**Grand Wayne Convention Center
Outdoor Event Space - Patio
9/18/2026****ADDENDUM NO. 2**

This addendum is issued as a supplement to the plans and specifications and shall be considered an integral part of the same.

OUTDOOR EVENT SPACE - PATIO

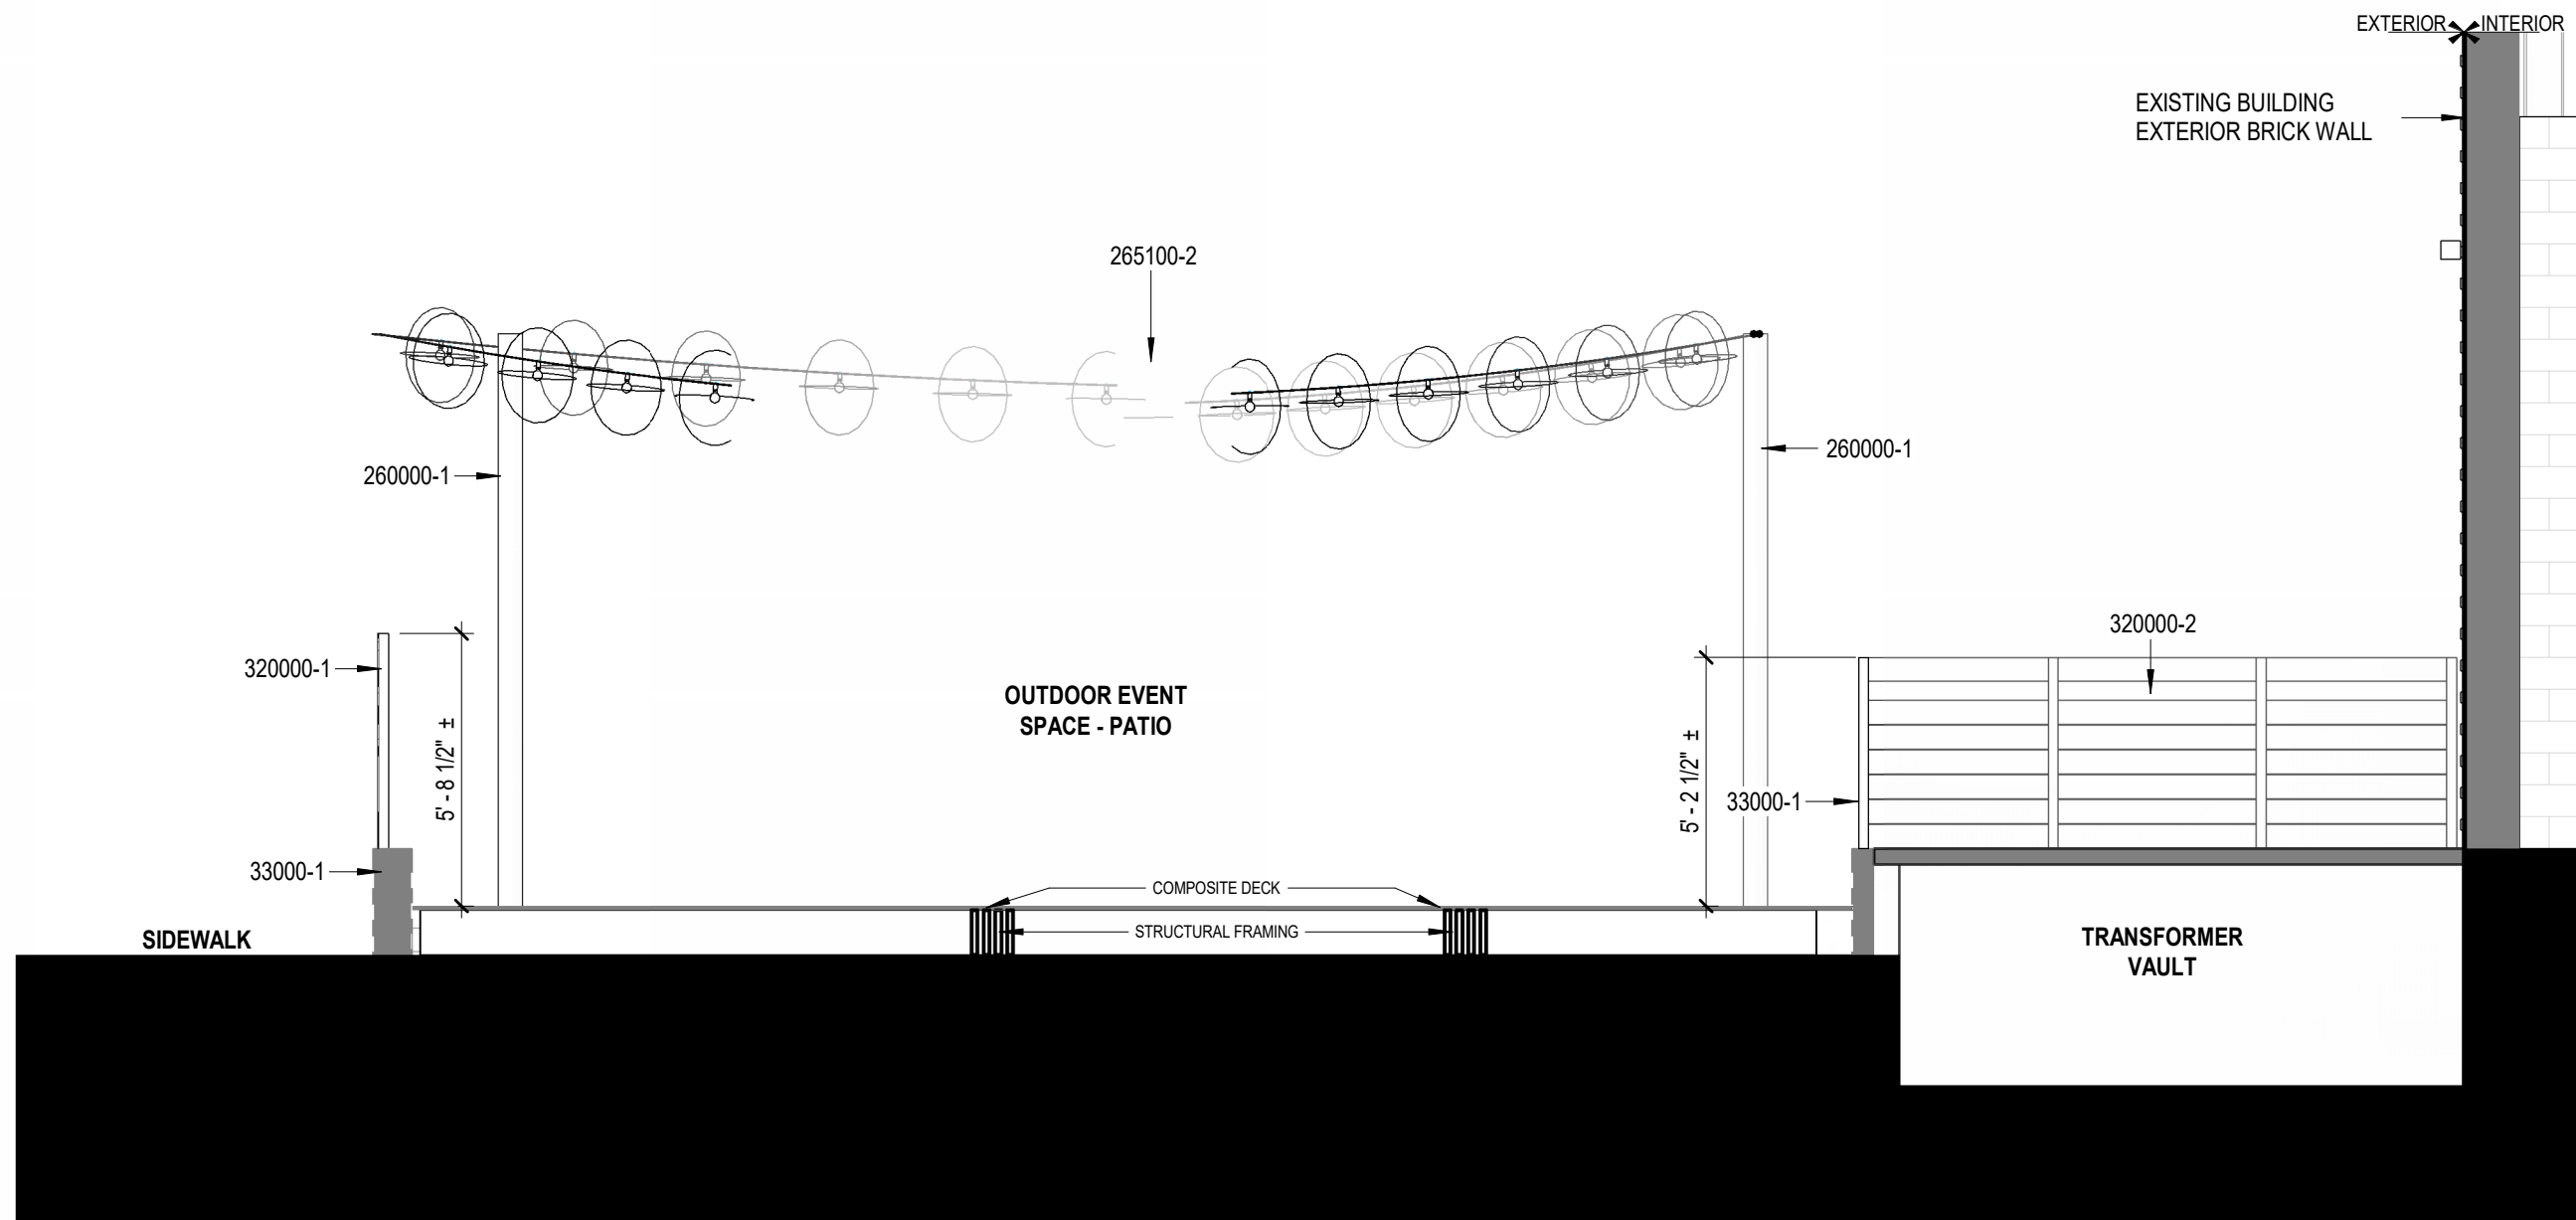
Item: 2.03
Location: E1.1 Electrical Plan - Main Level
Description: Provide egress remote light fixture mounted to poles near gates. Provide remote battery inside building.

1 ARCHITECTURAL SITE PLAN
SCALE: 1/8" = 1'-0"

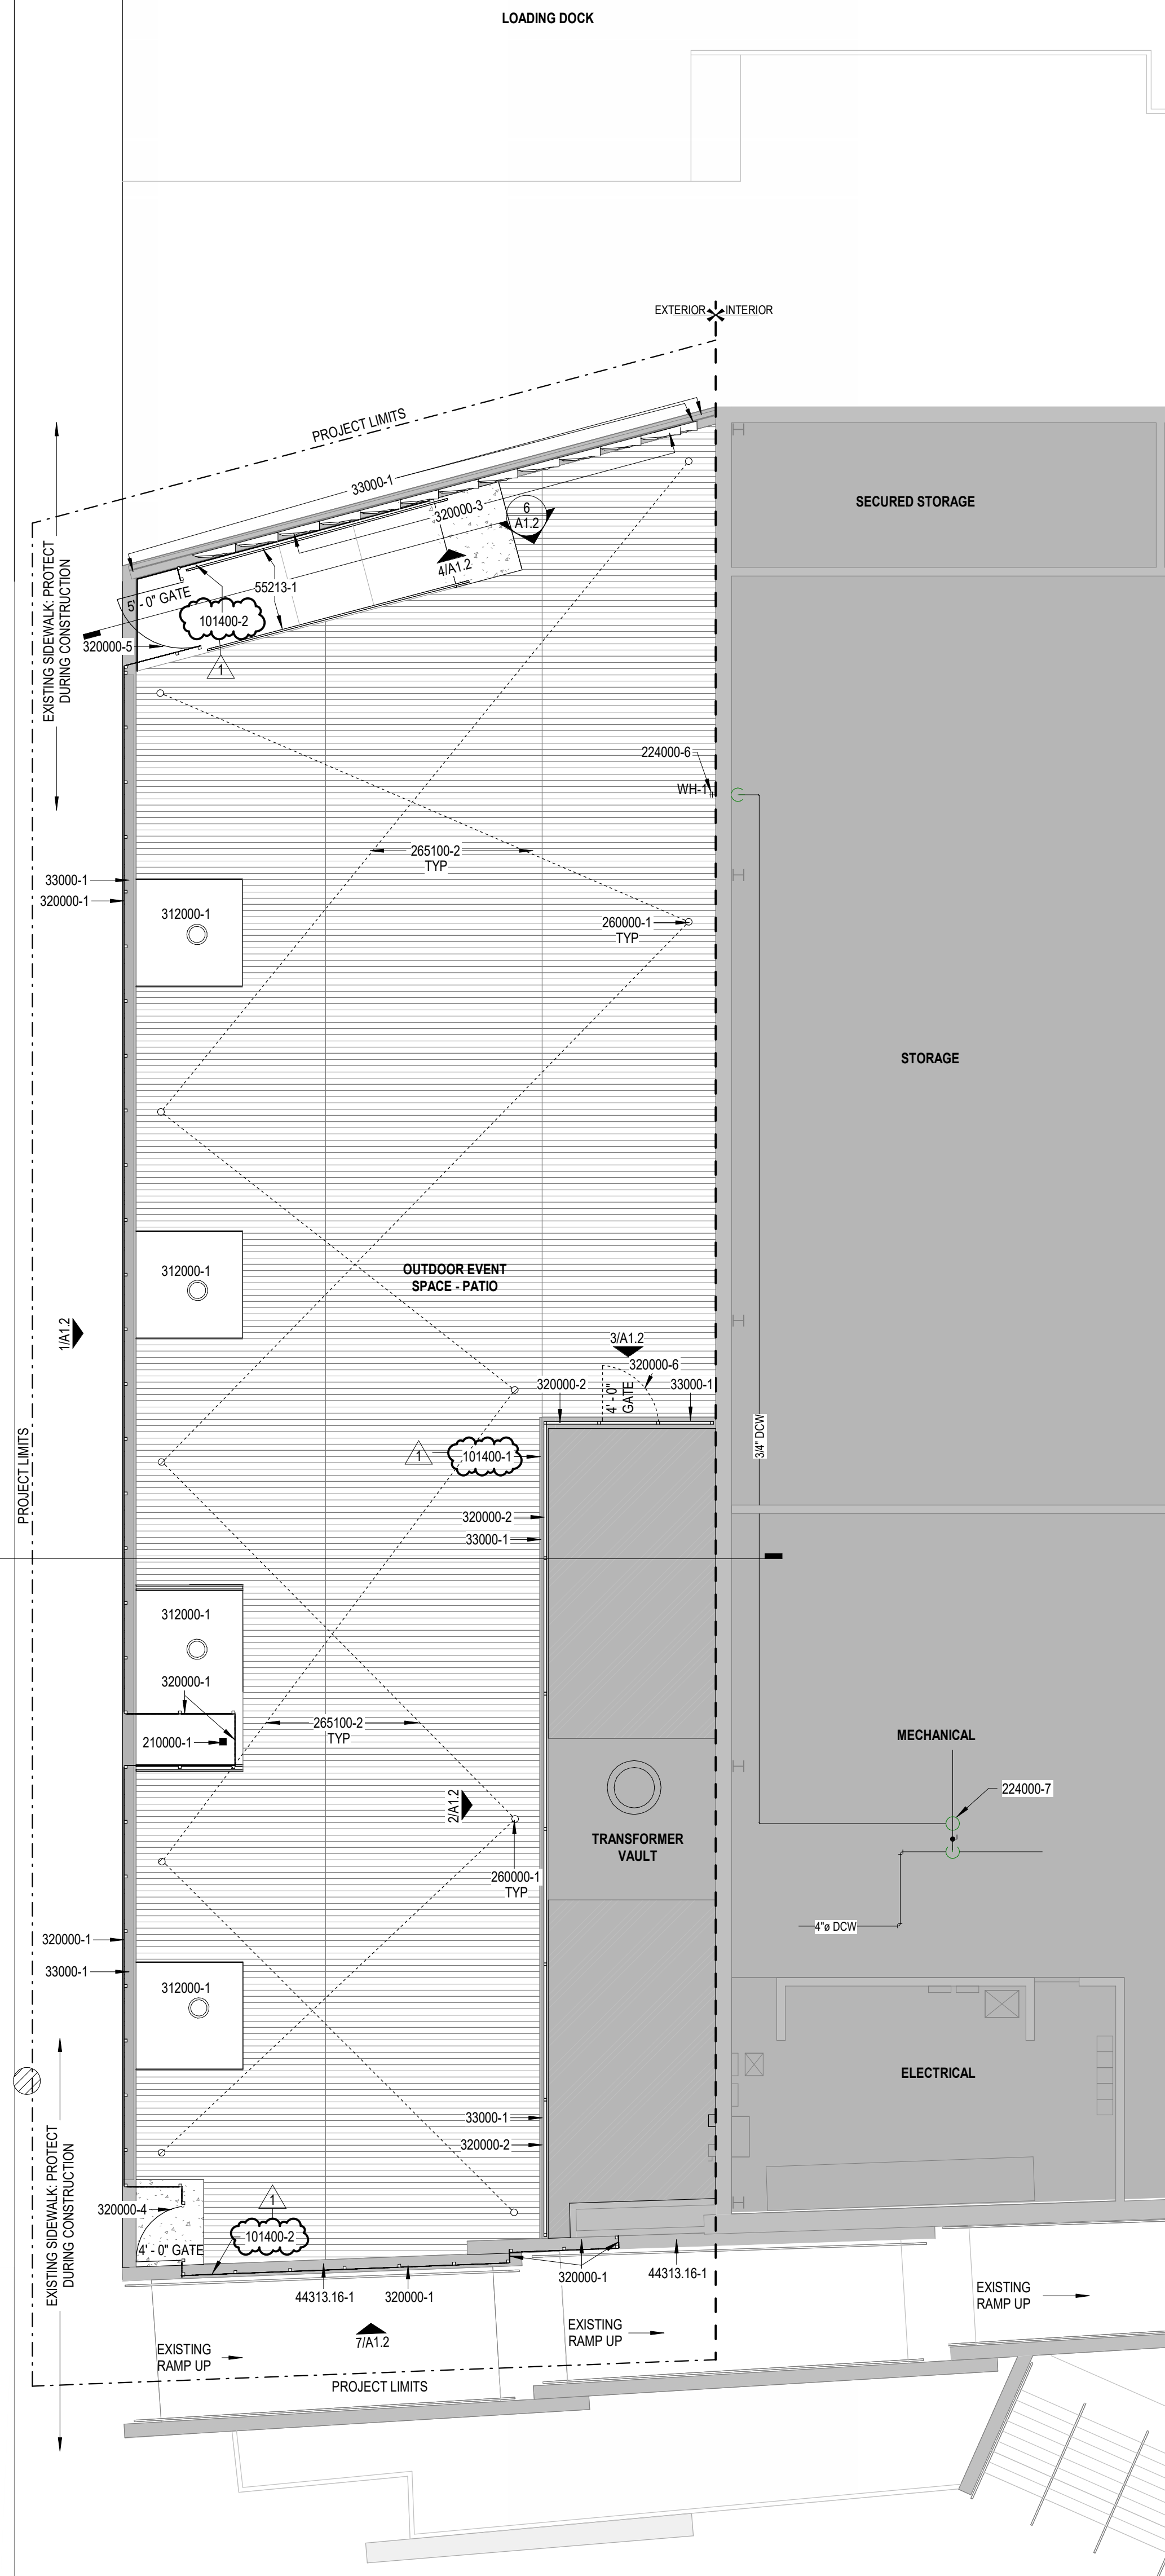
Item: 2.01
Location: A1.1 Architectural Site Plan
Description: Signage (provided by Owner and GC installed) shall include exit signs (unlit) at both gates as well as an occupant load sign. See added keynotes 101400-1 and 101400-2.

Item: 2.02
Location: A1.1 Architectural Site Plan & A1.2 Exterior Elevations
Description: Keynotes 320000-4 and 320000-5 updates to include panic hardware with lock box at both gates.
